**PARK CITY BOARD OF ADJUSTMENT MEETING
SUMMIT COUNTY, UTAH
March 19, 2024**

Subject: 844 Empire Avenue
Application: PL-24-06051
Author: Caitlyn Tubbs, Senior Planner
Date: March 19, 2024
Type of Item: Variance – Front Setbacks

Subject: 317 Ontario Avenue
Application: PL-24-06038
Author: Caitlyn Tubbs, Senior Planner
Date: March 19, 2024
Type of Item: Variance – Tandem Parking Requirement

948 WOODSIDE

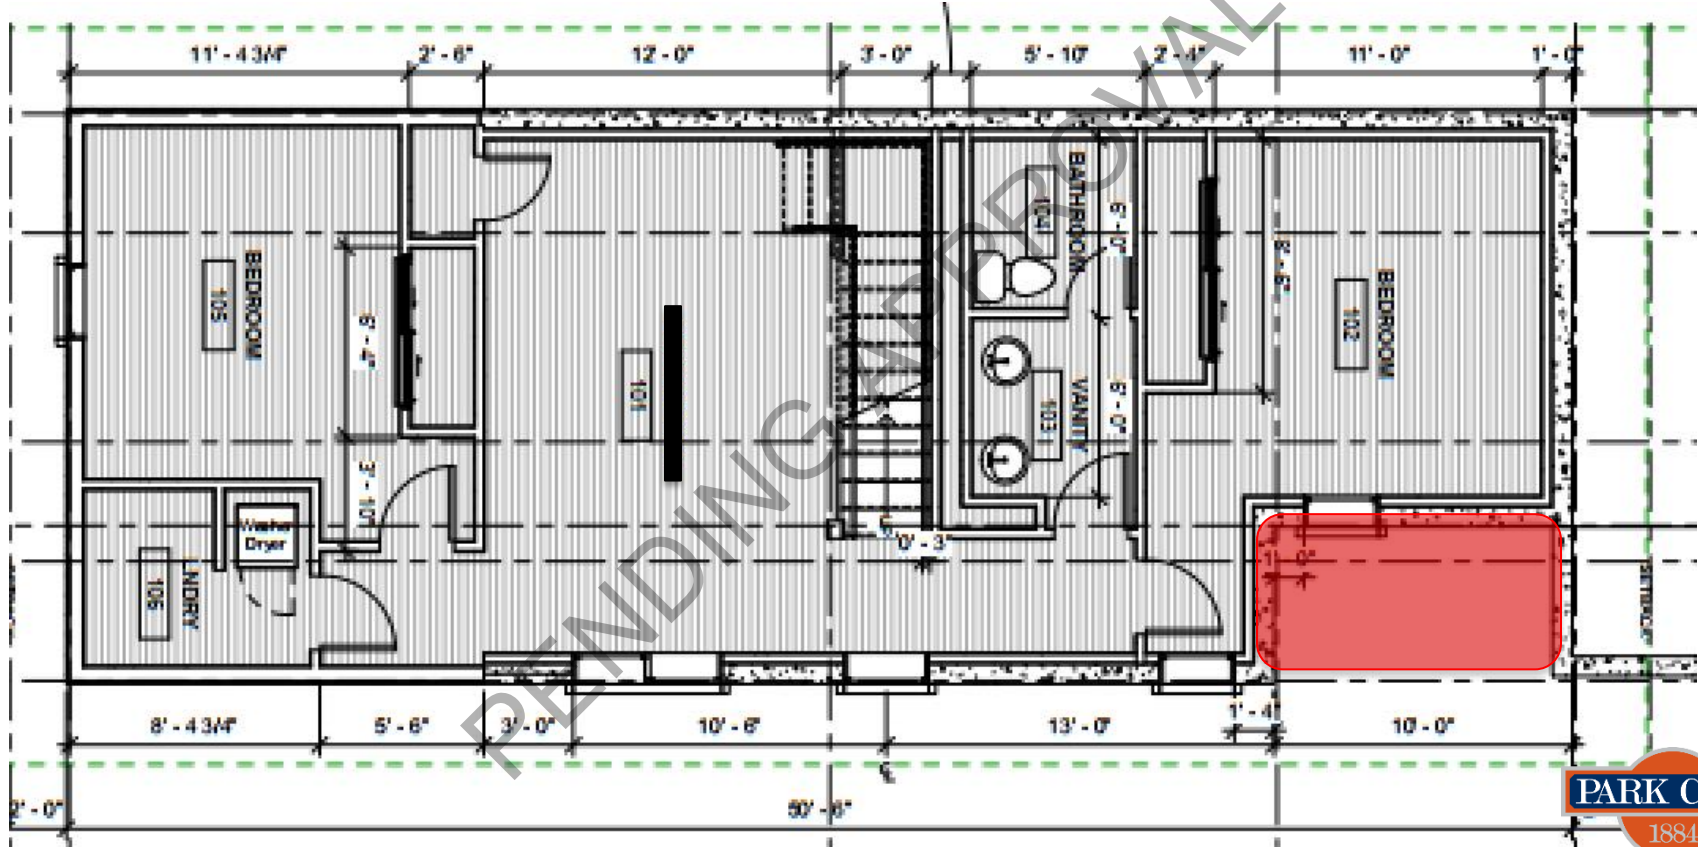
- Non-historic Single-Family Dwelling
- Increase Building Footprint from 909 to 960 square feet
- Construction of an additional bathroom on basement level
- Two bathrooms and three bedrooms – Existing
- Variance to increase the Maximum Building Footprint in HR – 1

Figure 3: Applicant's Site Plan showing internal dimensions of proposed garage addition.

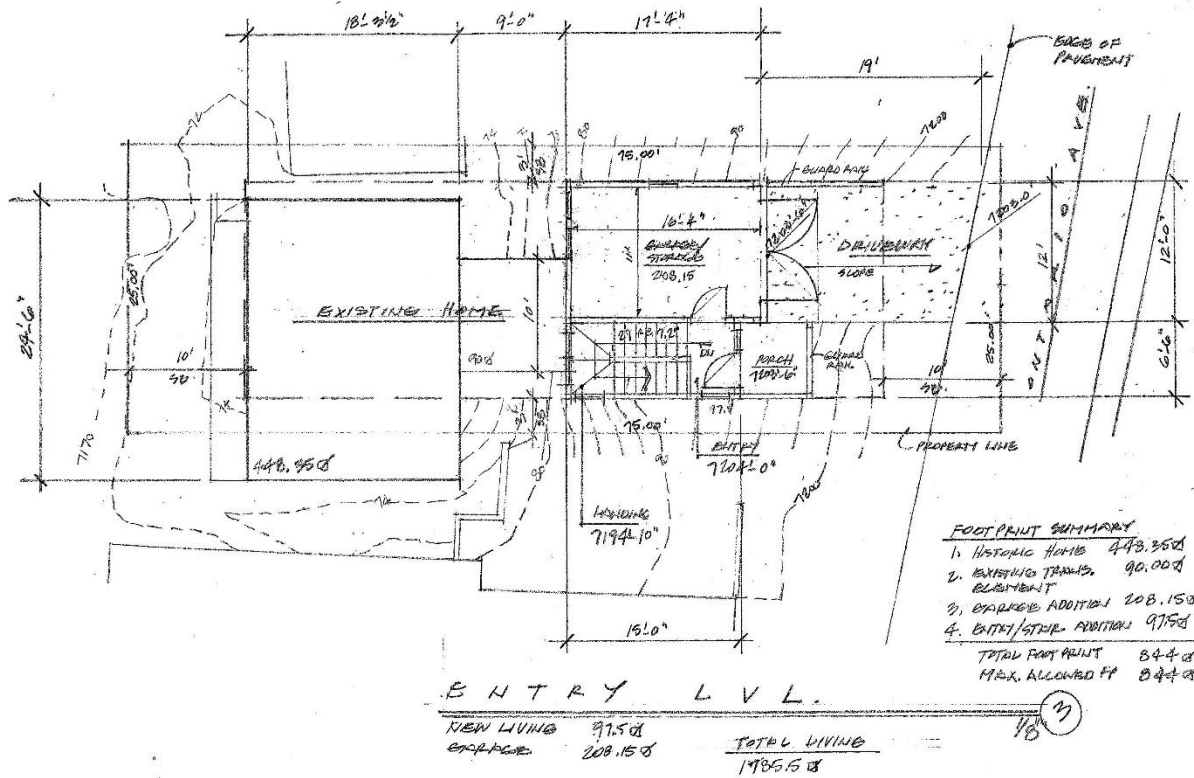
The Planning Commission approved the additional Building Height. However, the Applicant now requests an exception from the requirement that the Building Height exception for a single-car-wide garage provide a Tandem Parking configuration. The proposed single-car-wide garage only provides one interior garage parking space of eleven feet in width and sixteen feet four inches in depth. The driveway is twelve feet in width and nineteen feet in depth and cannot provide the required Tandem Parking configuration.

The subject property is partially occupied by the Ontario Avenue public right-of-way which restricts the Applicant’s ability to provide a second tandem off-street parking space on the proposed driveway. The depth of the driveway does not provide the required dimensions before it meets the Ontario Avenue right-of-way, and is not enough space to accommodate the minimum parking dimension for a tandem space.

Figure 4: North elevation of Historic Structure and proposed addition, showing transitional element in blue.

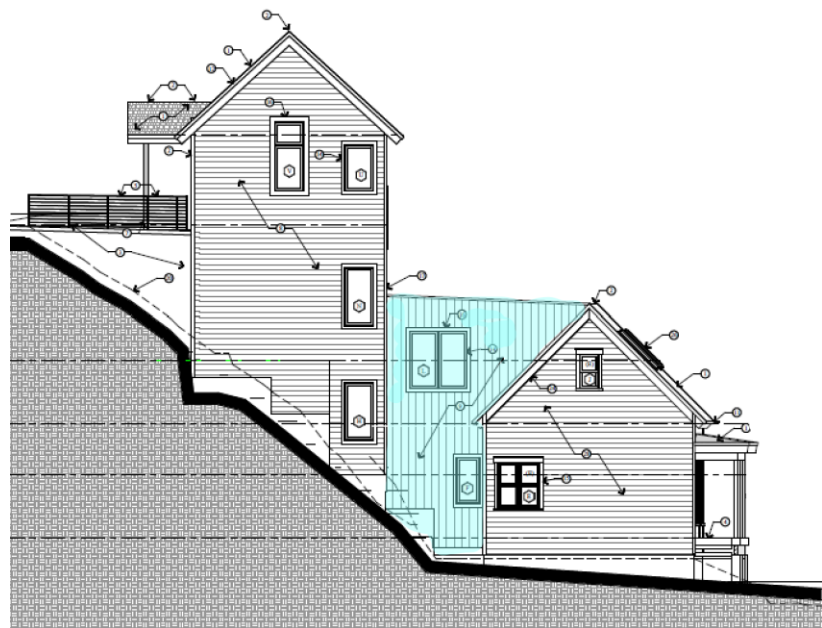
The preservation of the existing Historic Structure and the inclusion of the transitional element maintains the Historic Character of Old Town as is widely supported in the General Plan. The keeping of vehicles out of the front yard setback areas allows for a more traditional streetscape that is consistent with the purpose of the standards adopted in the HR – 1 Zoning District and the Regulations for Historic Residential Sites. Providing parking within the proposed garage while also not requiring a second tandem parking space further advances the maintenance of the Historic Character of the Site.

SHEET NUMBER:
A1.1

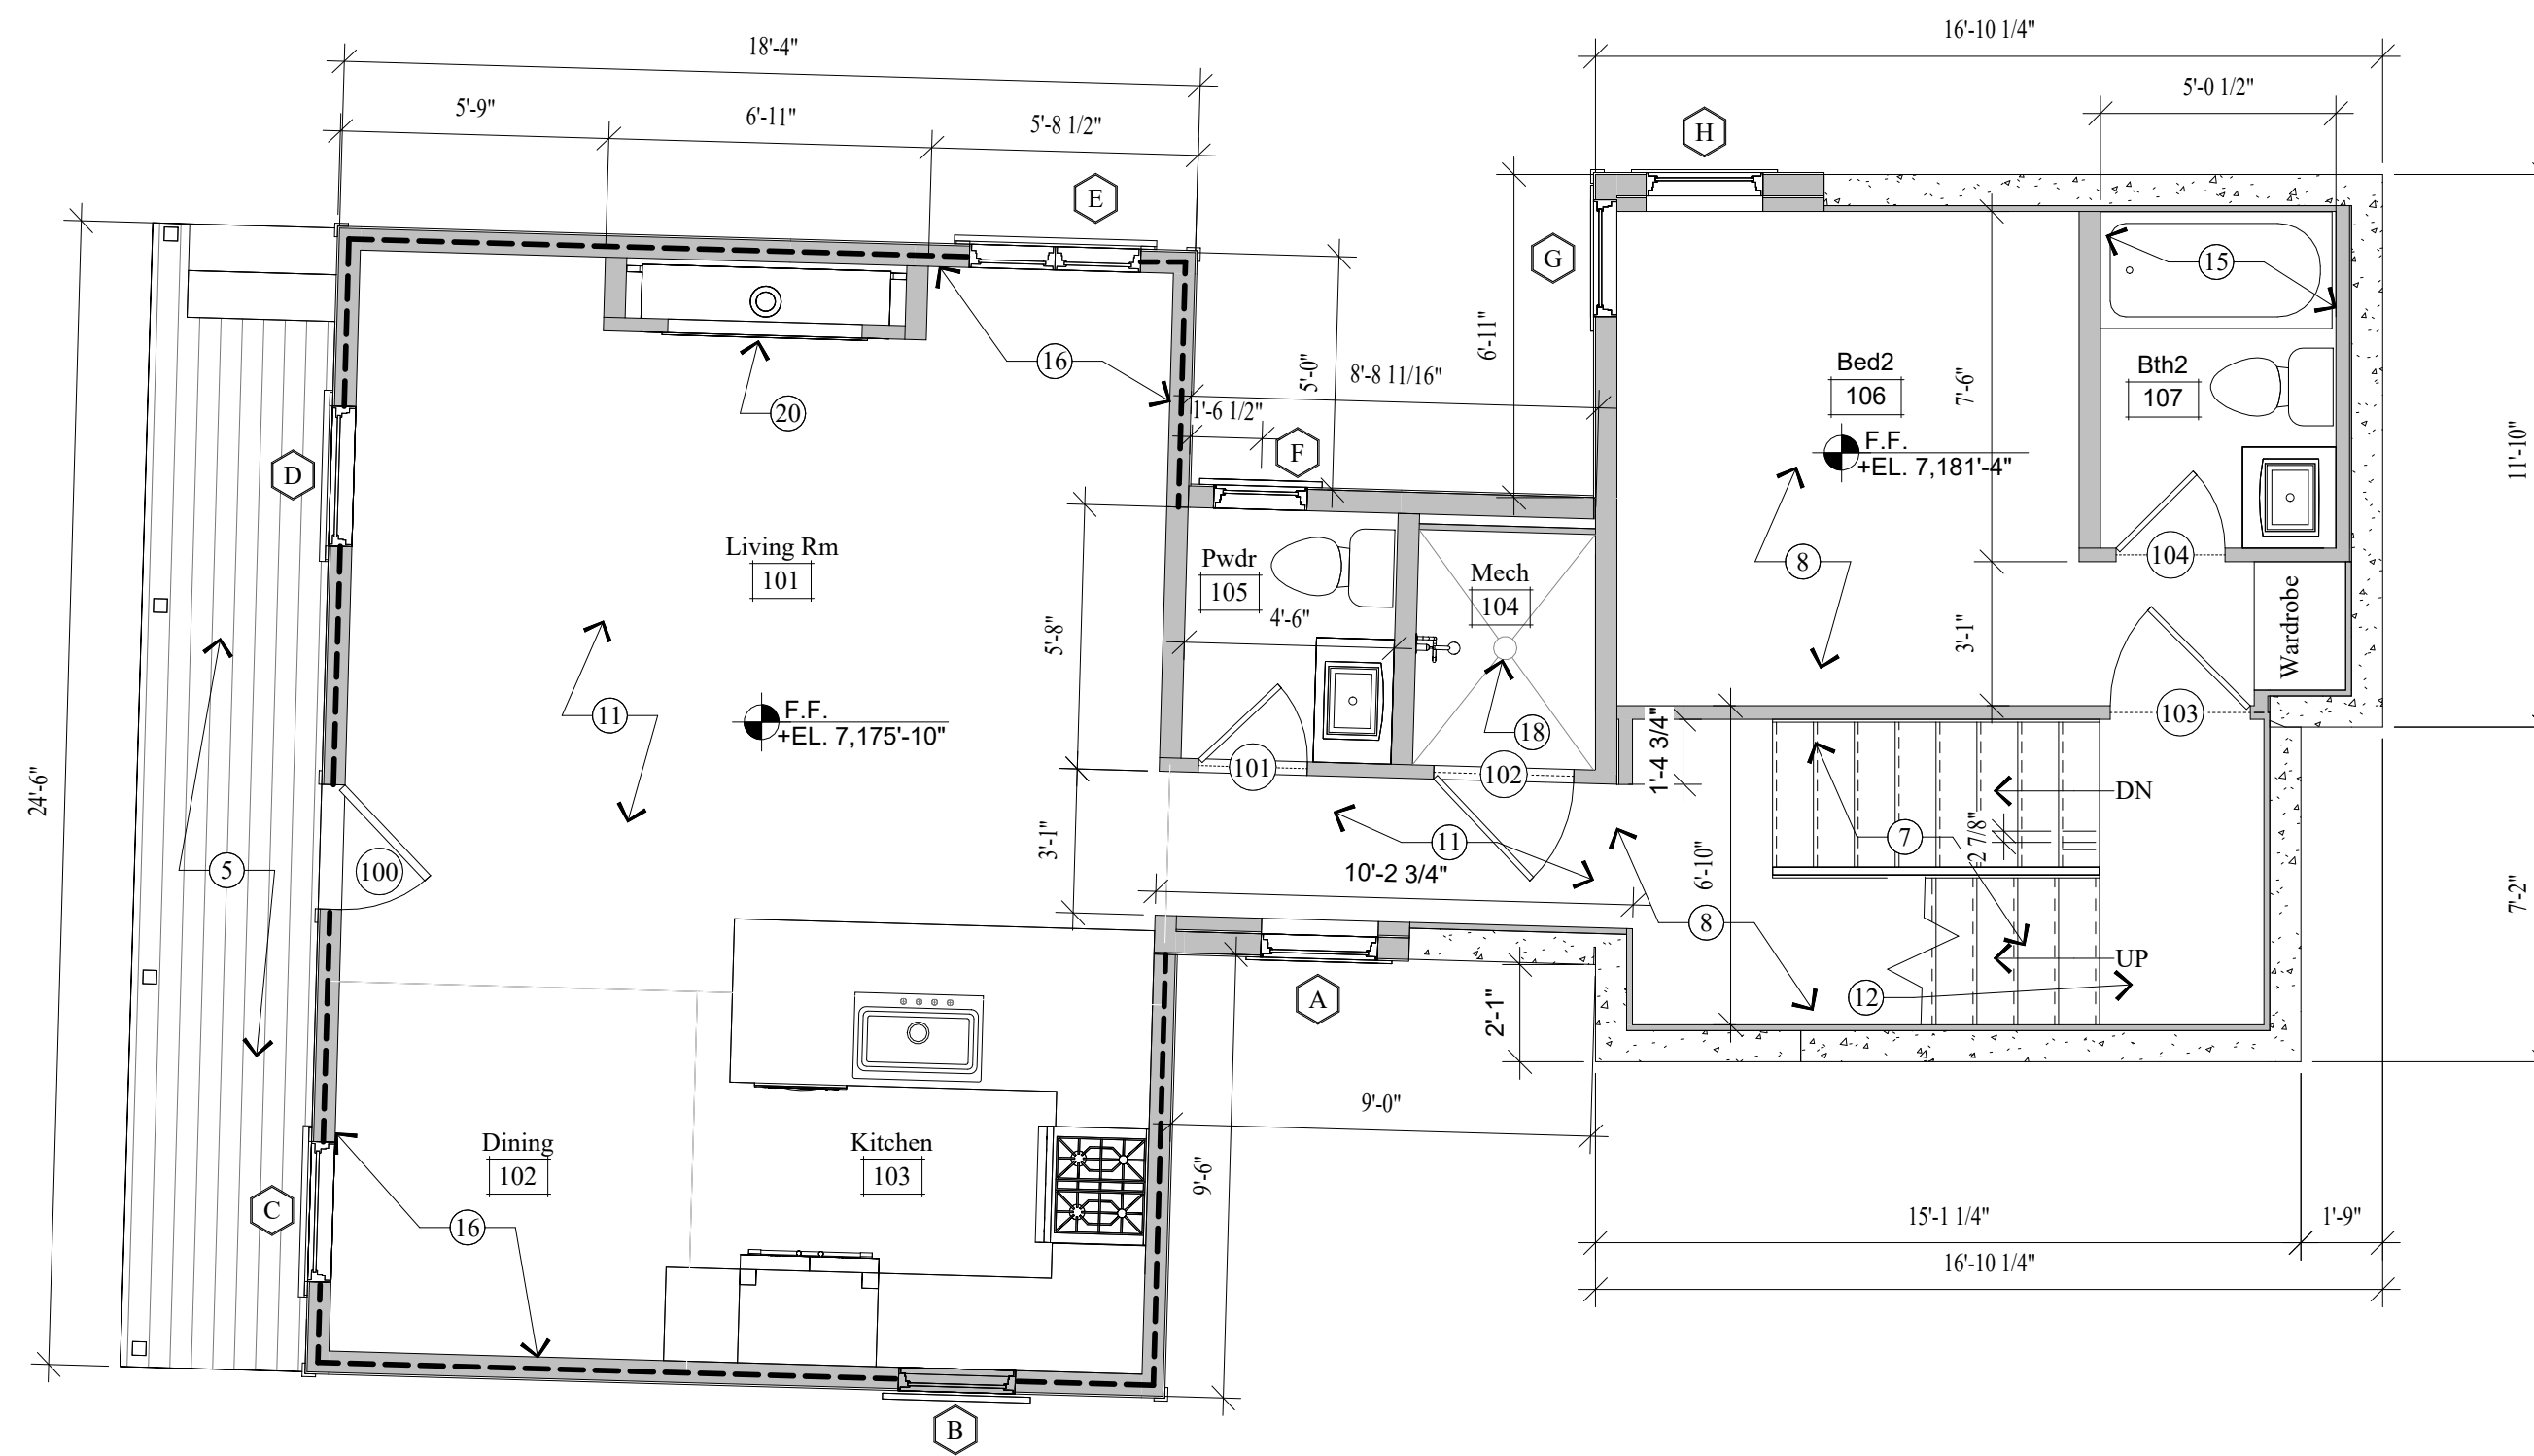
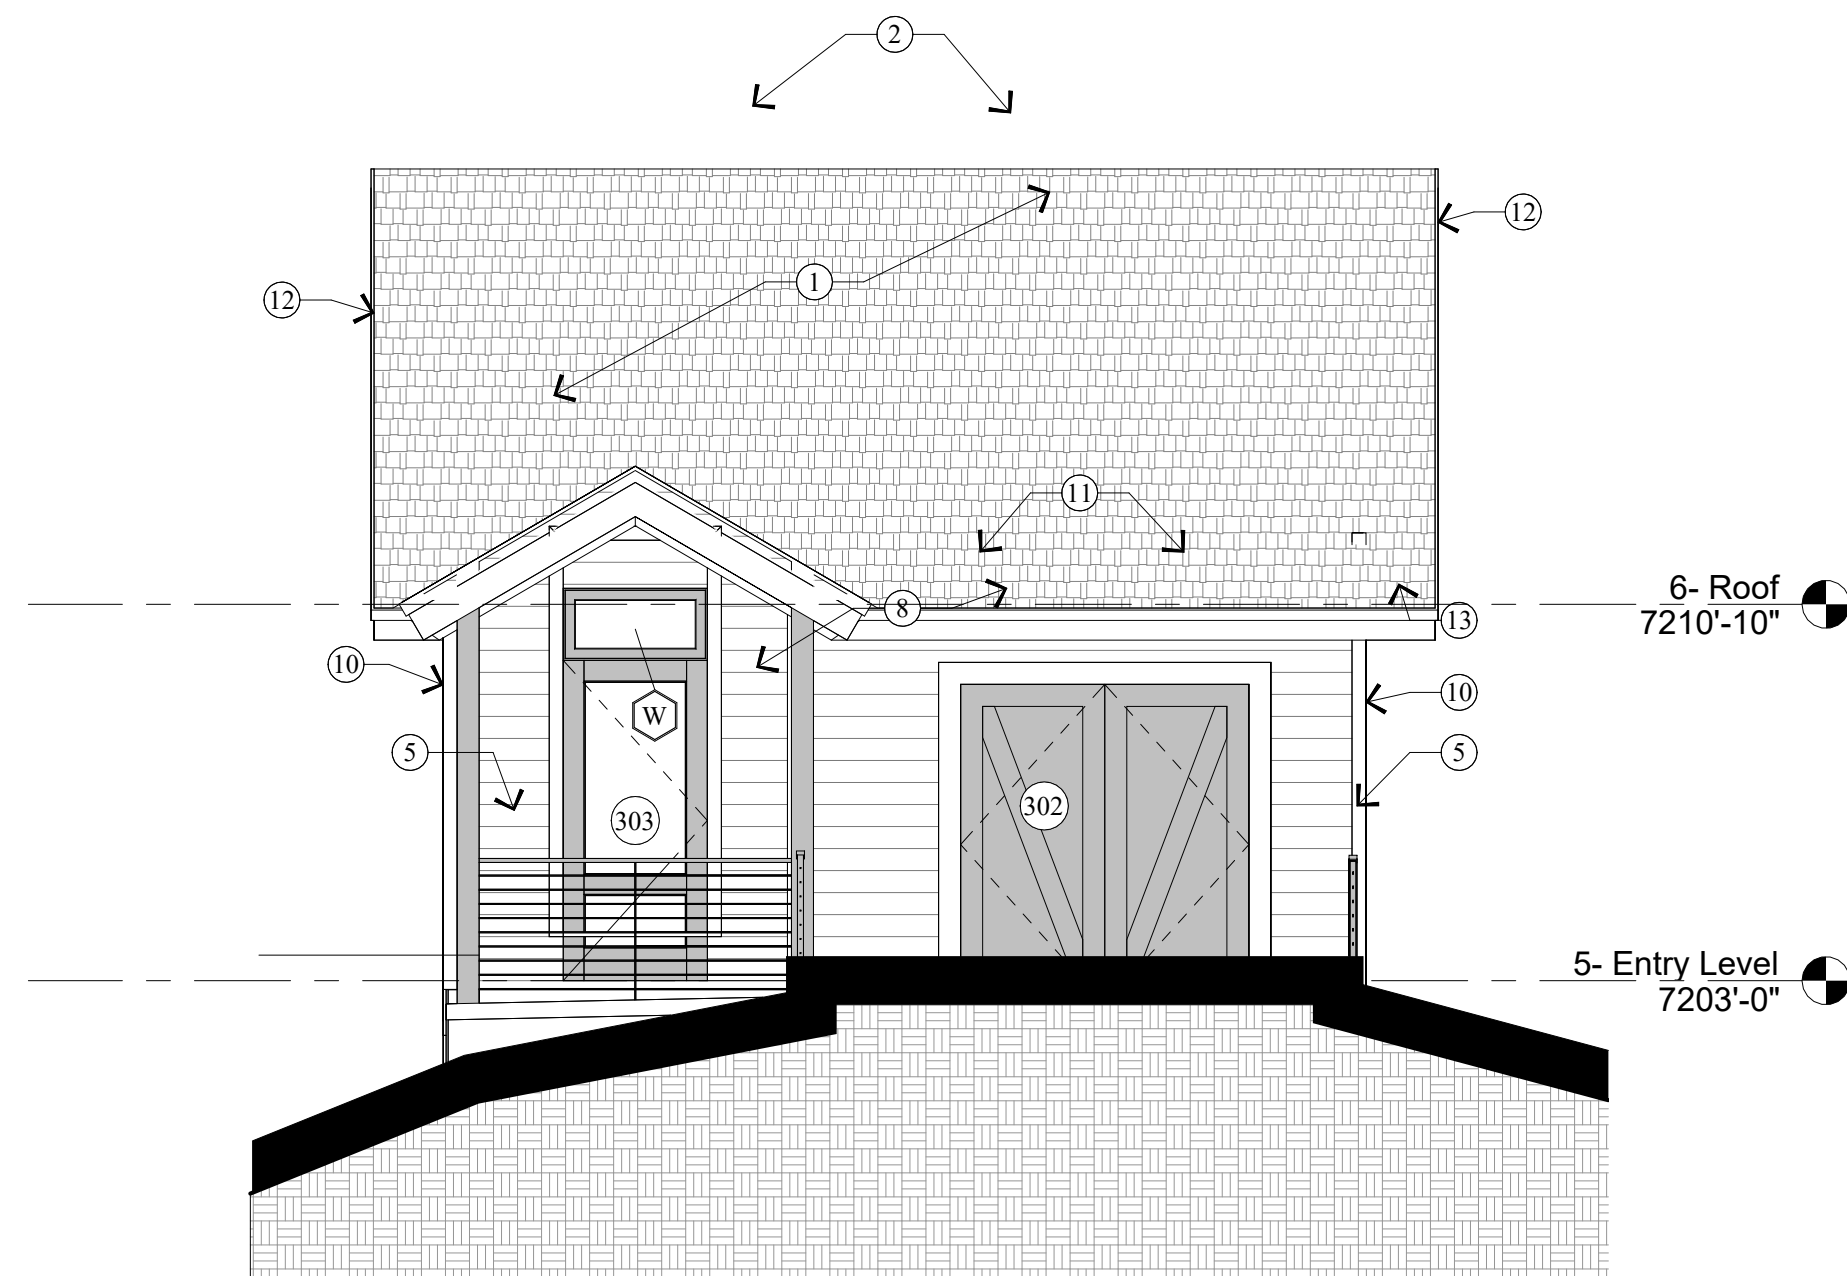
I've included floor plans in the application, Exhibit "A", sheet A1.1, that shows the footprint of the existing home, the required transition element, and the proposed addition. When the existing home and transition element footprint is subtracted from the allowable 844 sq. ft. footprint the remaining area equals 305.65 sq. ft. This addition needs to incorporate the main entry, a stair, and garage area as it will be adjacent to Ontario Avenue and is the entry to the home and connection to the public way. Once the stairs and entry are subtracted from the 305.65 sq. ft. the remaining area yields a garage of 11'-1" in width and 16'-2 1/4" in depth. Since the required depth of a single car garage is 20', we need a variance of 3'-9 1/2". It should be noted that the code does allow compact spaces as small as 9'x16', see 15-3-3, section F, for surface parking spaces.
